**TESTIMONY OF JOE MEHRA, P.E. PTOE, IN OPPOSITION TO THE 923-925 5<sup>th</sup> Street NW, Hotel, BZA Case No. 19722. (May 17, 2018)**

I have reviewed the Revised Comprehensive Transportation Review (CTR) study prepared by Gorove/Slade, dated May 4, 2018 and the response to my report submitted to BZA (response by Gorove/Slade is dated May 3, 2018) and DDOT Report dated May 11, 2018. Based on my review, I continue to conclude that the Gorove/Slade CTR is incomplete and does not meet the CTR Guidelines. Further, the Loading Dock access would not function based on the data and information provided by Gorove/Slade in their revised report.

Figure 10: Outbound Truck Turning Maneuvers

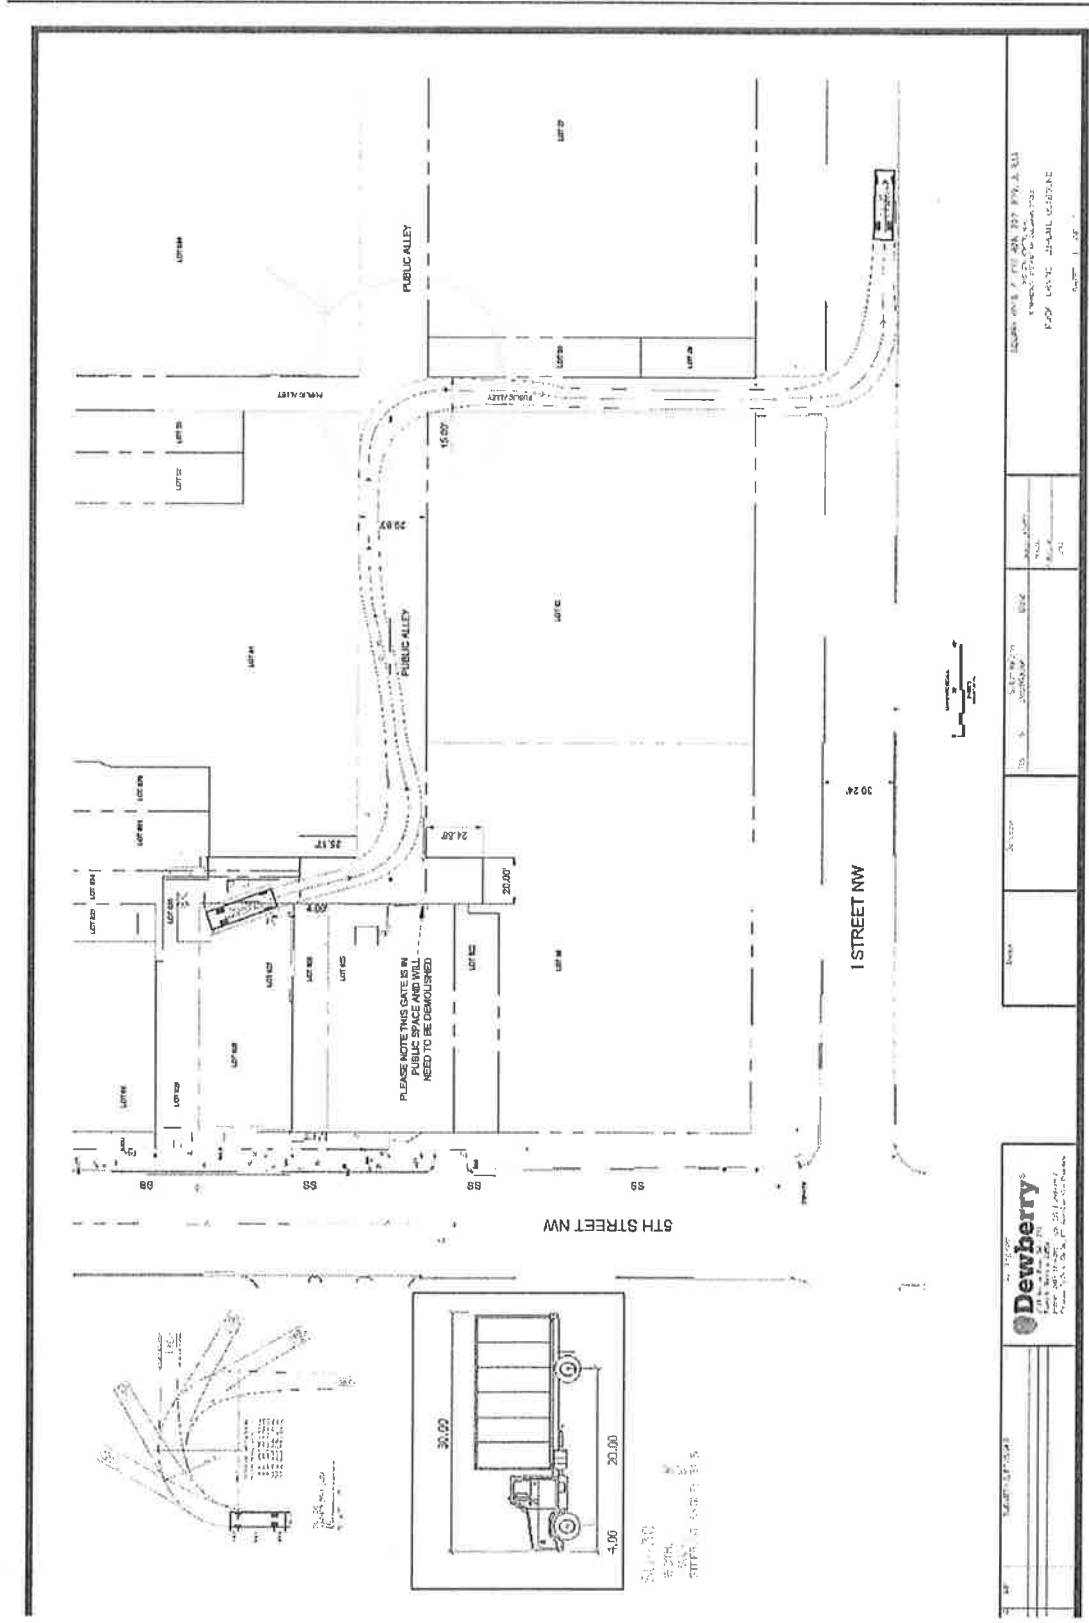
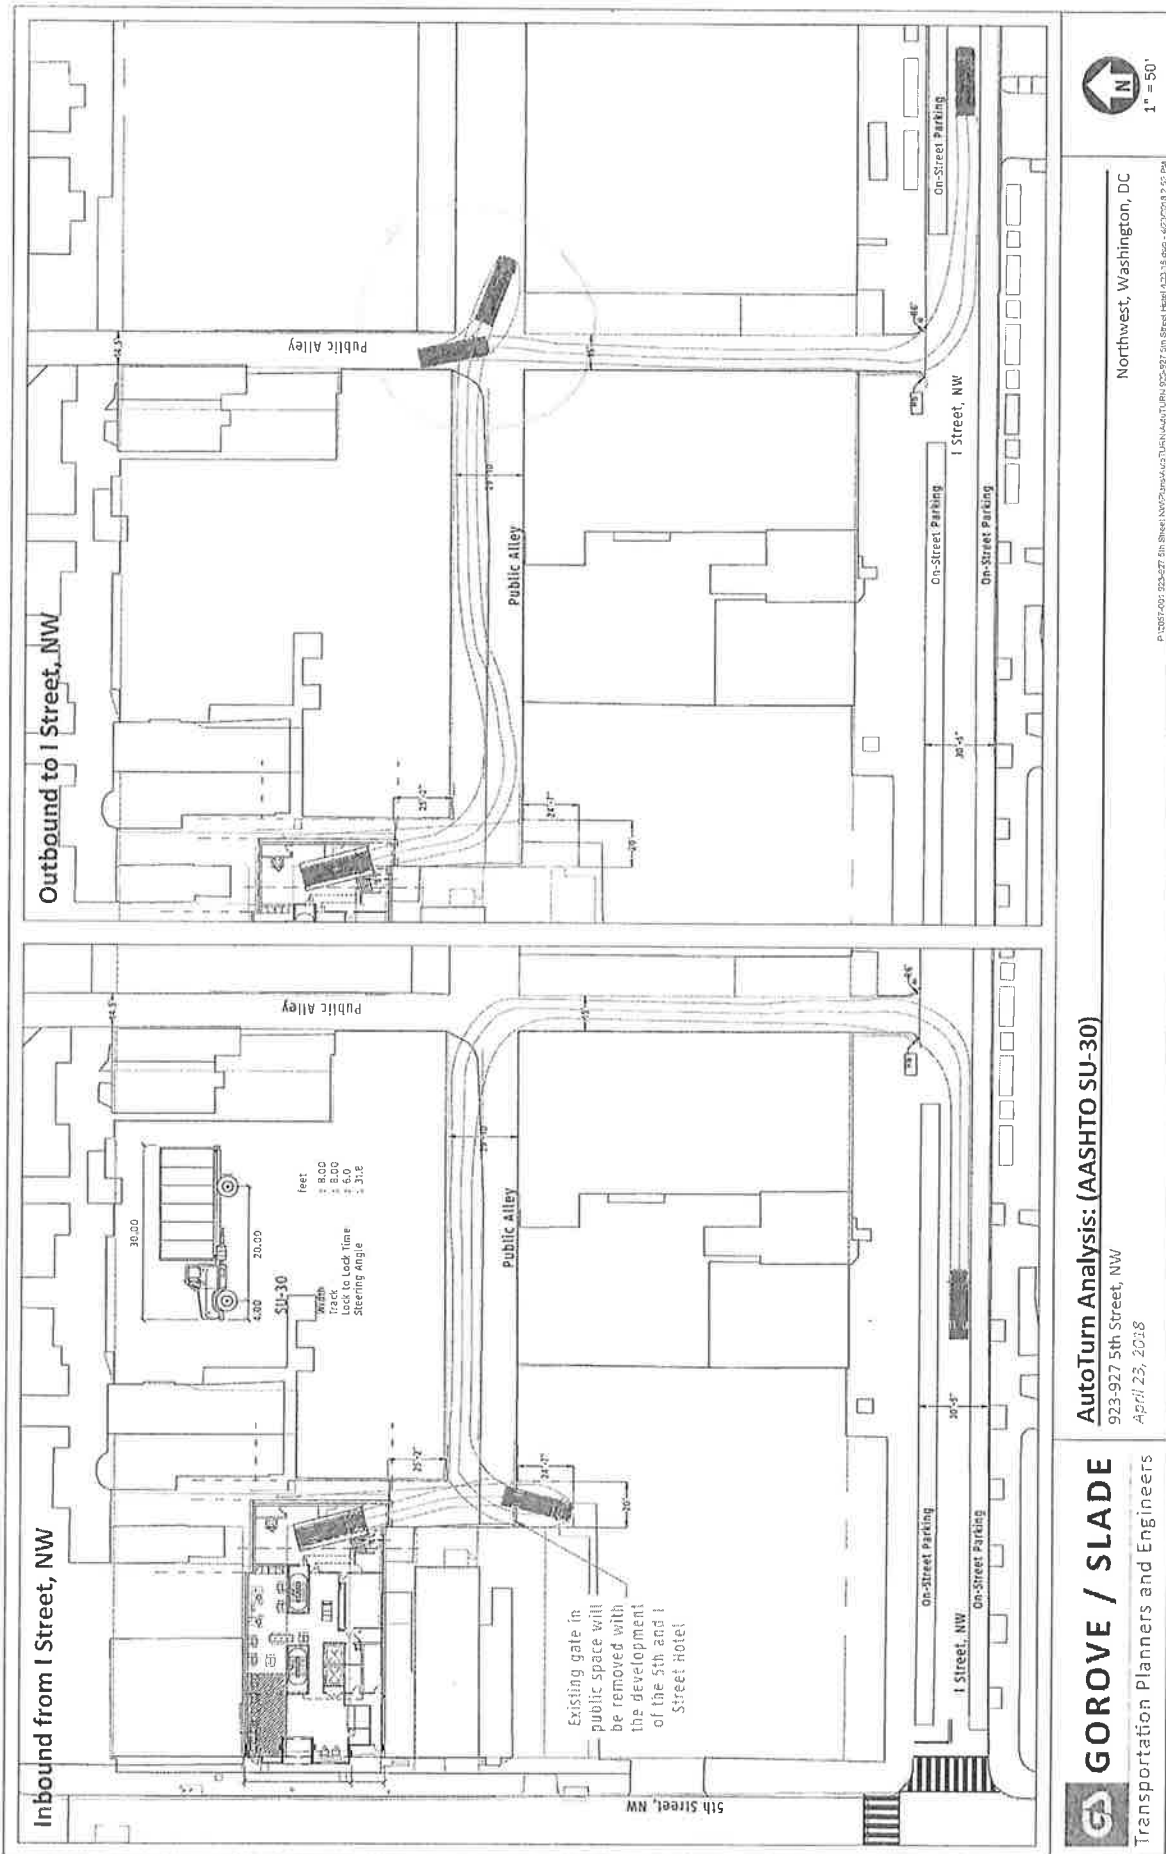
The traffic study does not meet the CTR guidelines and should be conducted by meeting with DDOT for a Scoping and conduct a full review of traffic impacts. The single loading dock may not meet the needs of the hotel (Zoning requires two loading berths). Further, the single loading dock provided is not accessible as per the truck maneuvers using AutoTURN as provided by Gorove/Slade.

PHOTO D

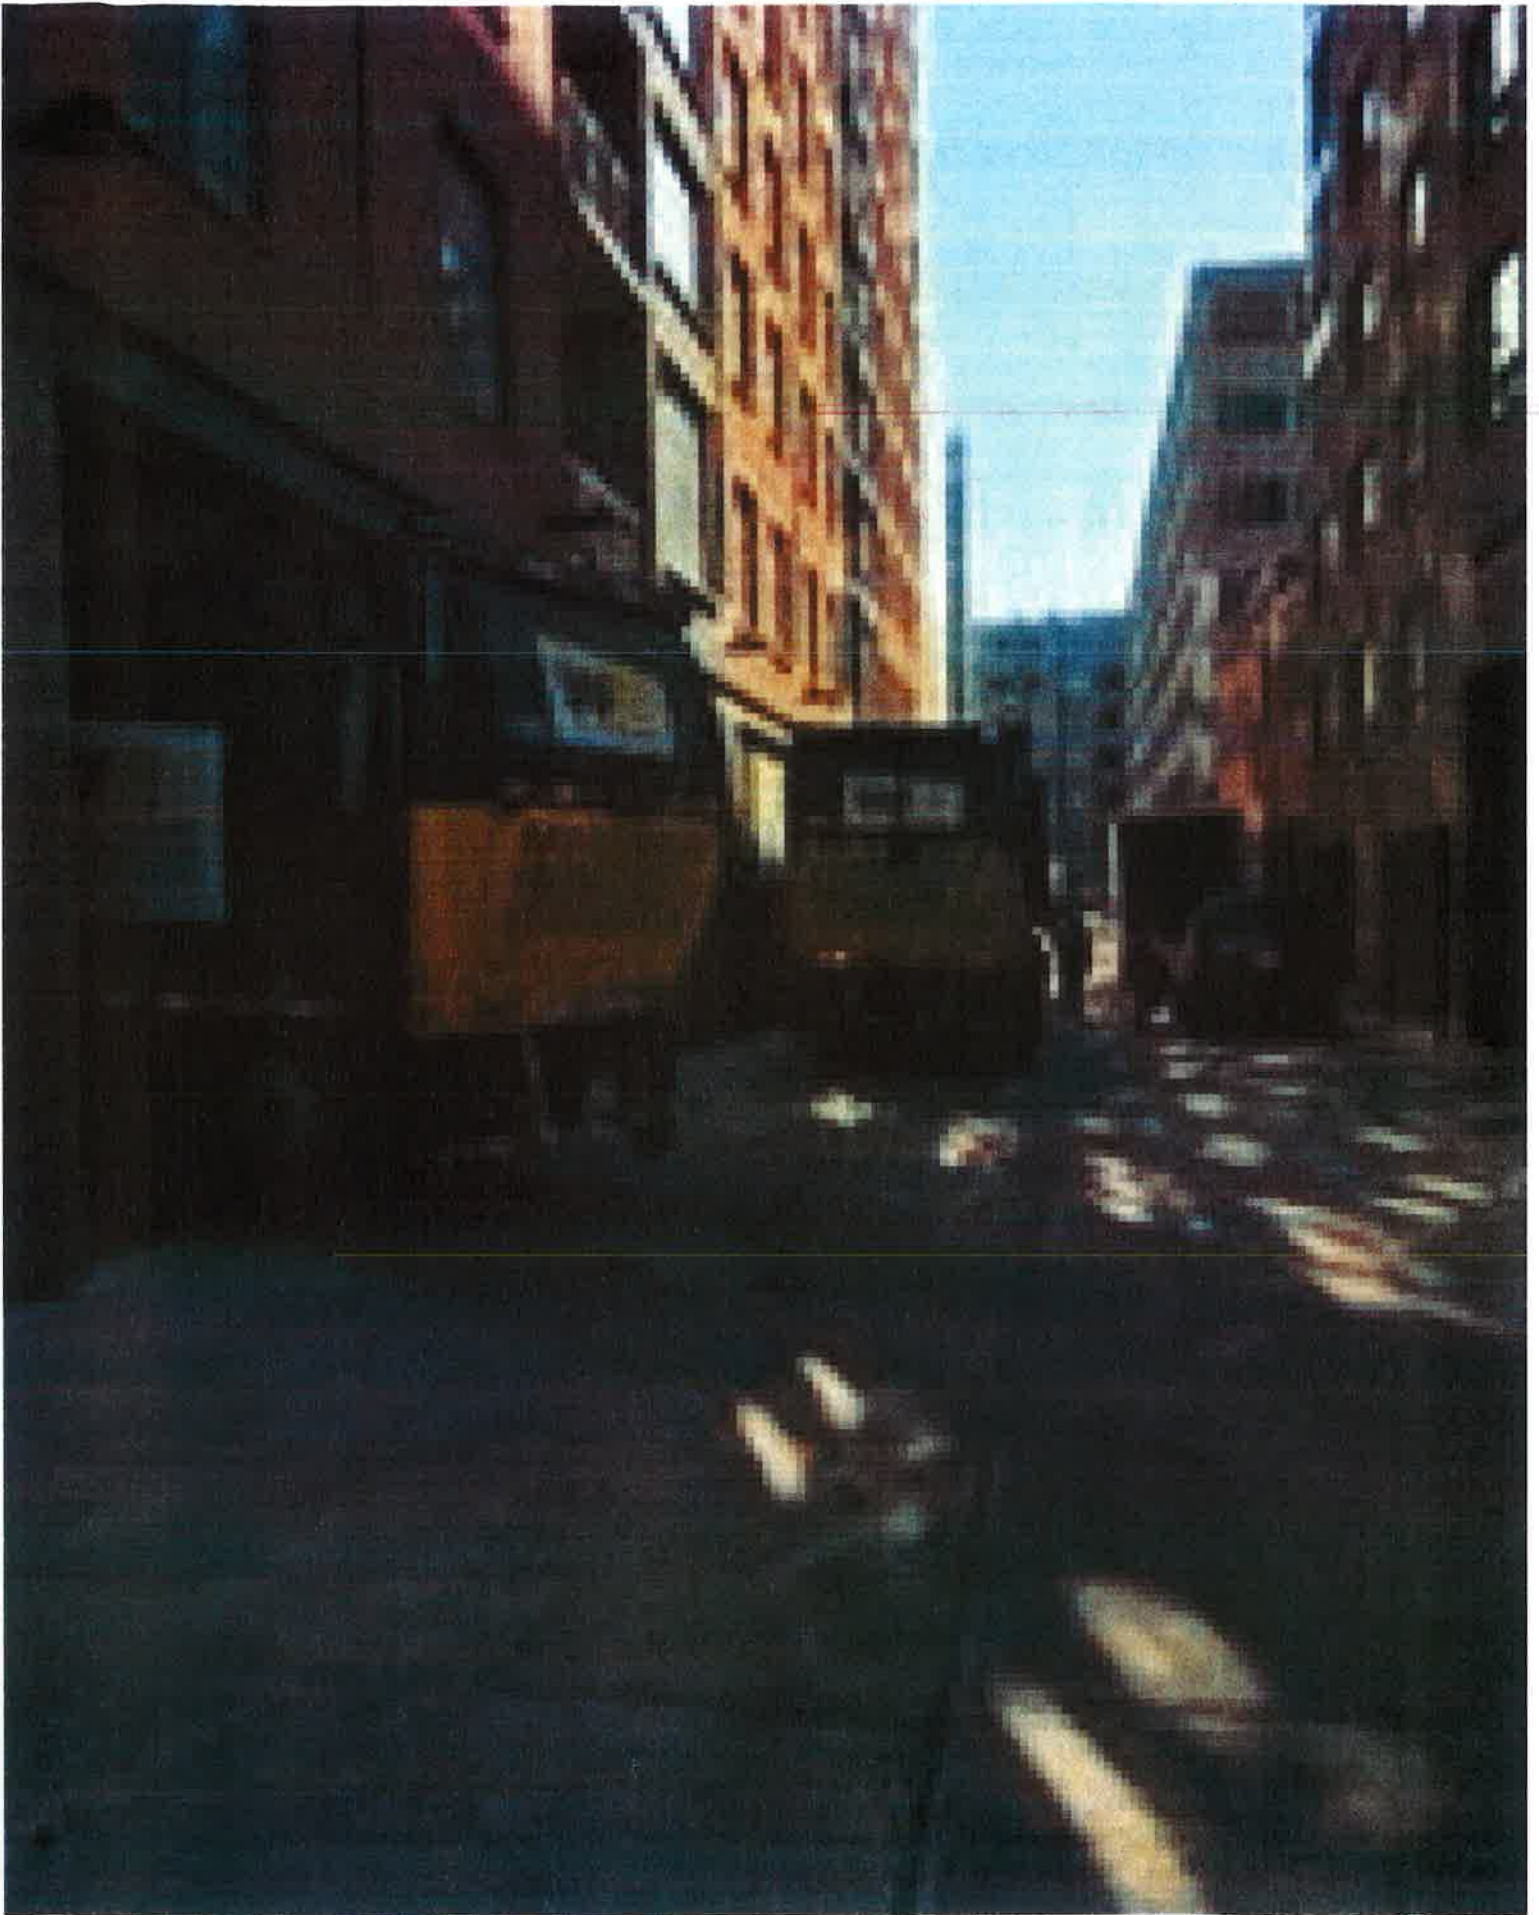
- C**     The driver is thinking "where and how do I back in?"
- D**     Two trash trucks + moving truck + vehicle blocked.
- E**     Trash truck blocking EW alley while unloading.

PHOTO G

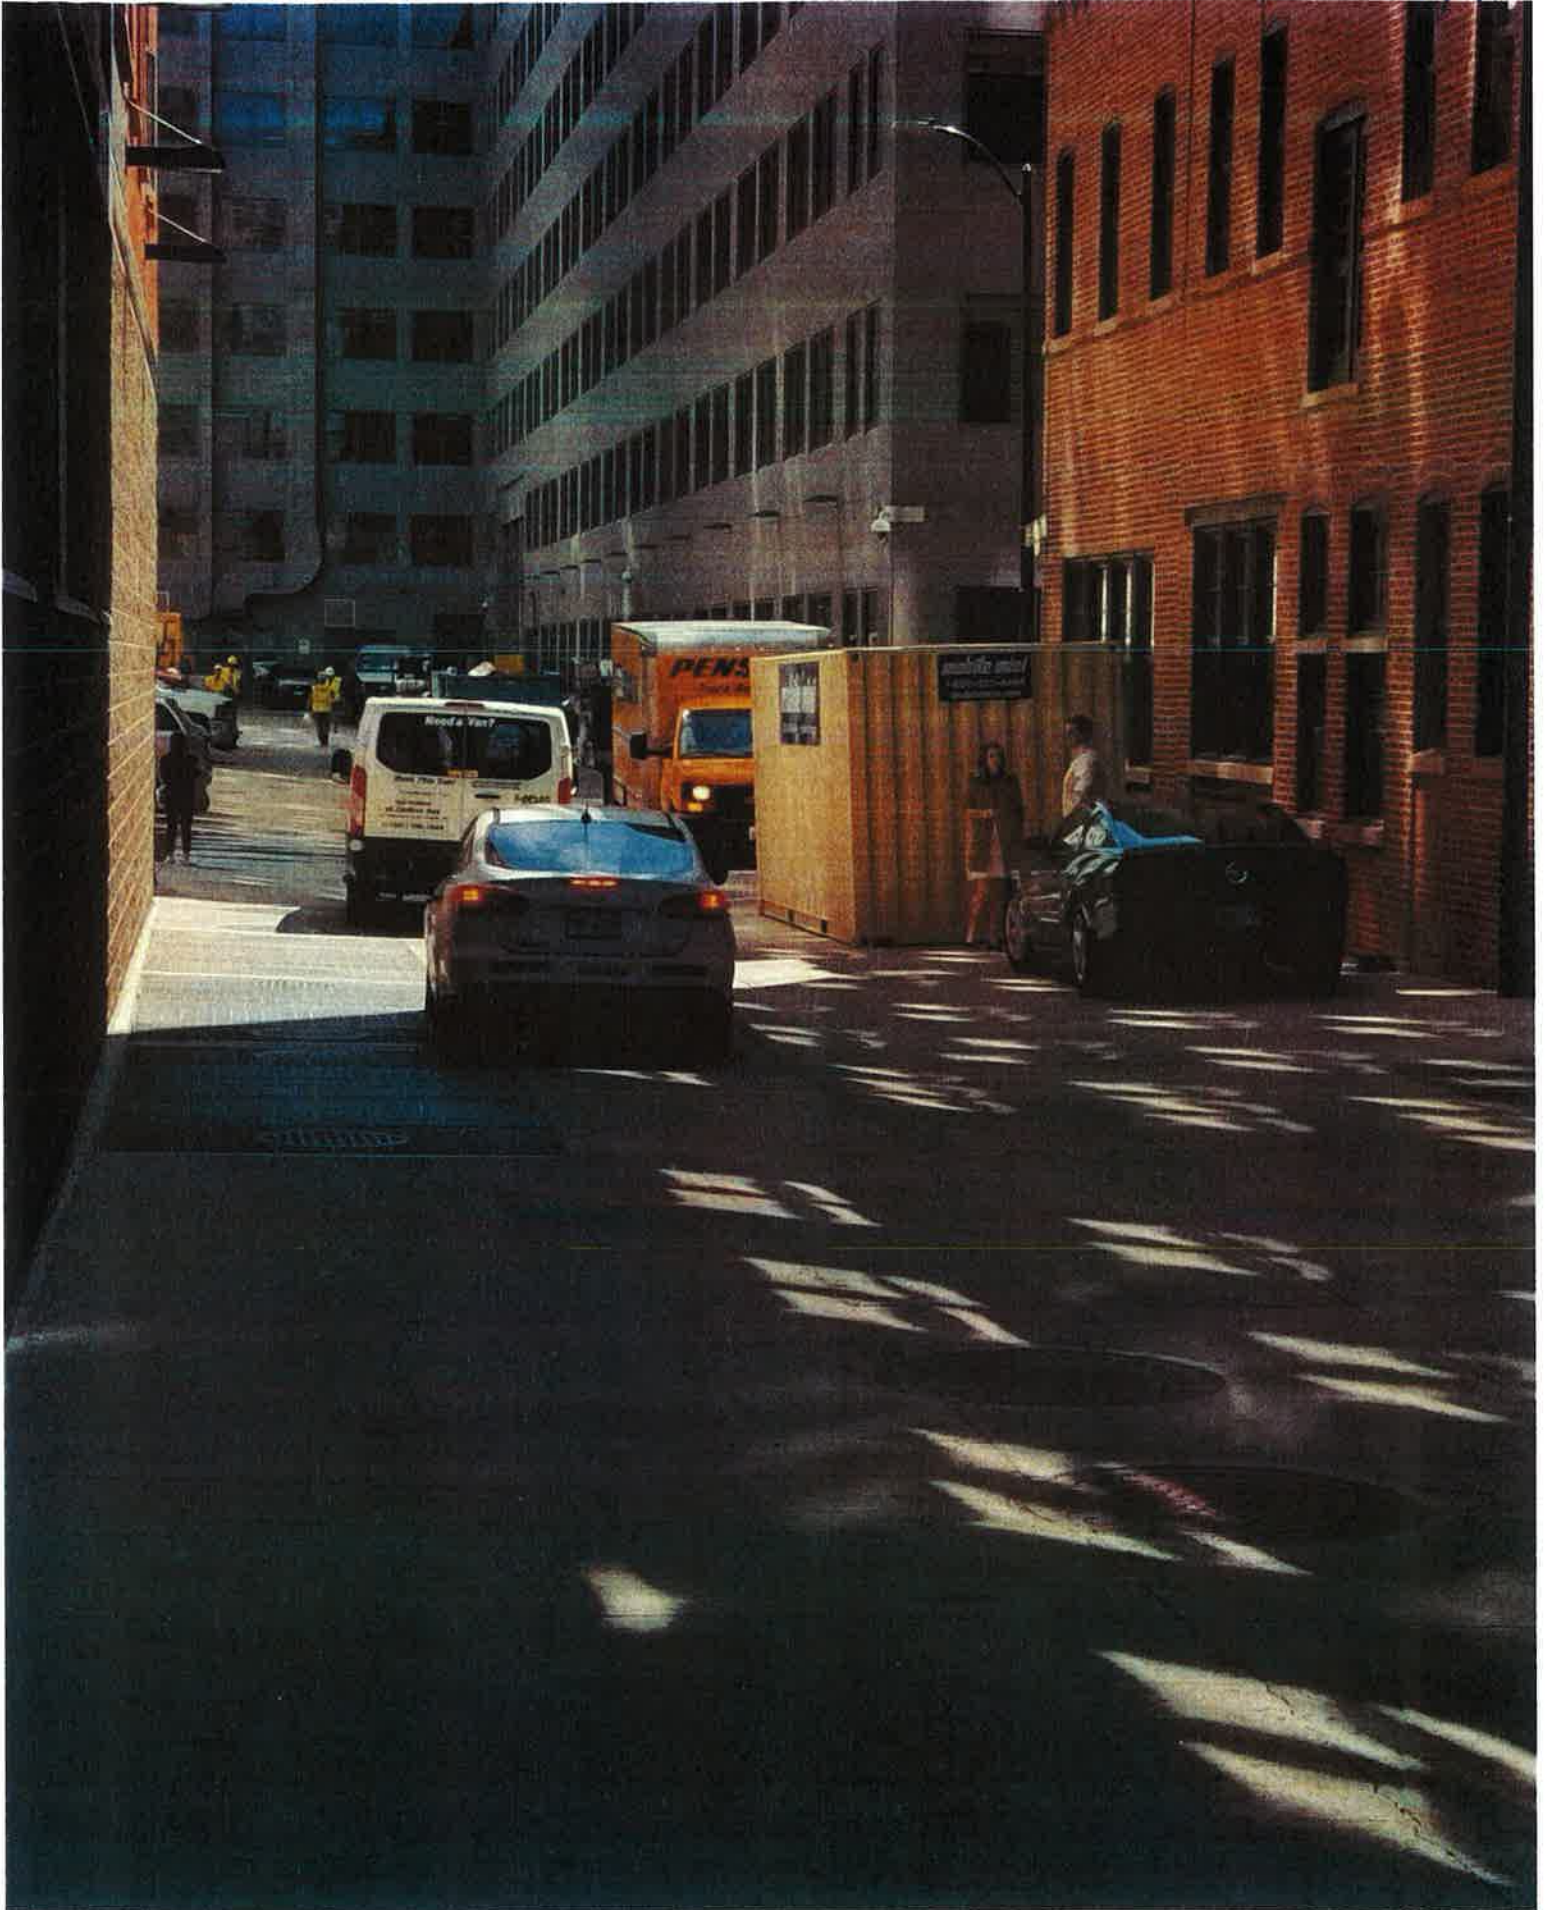
- F**     Trash truck backing and avoiding parked vehicles.
- G**     Ped/vehicle activity along NS alley.
- H**     Vehicle activities along alley.
- I**     Safety margin near bolstor.
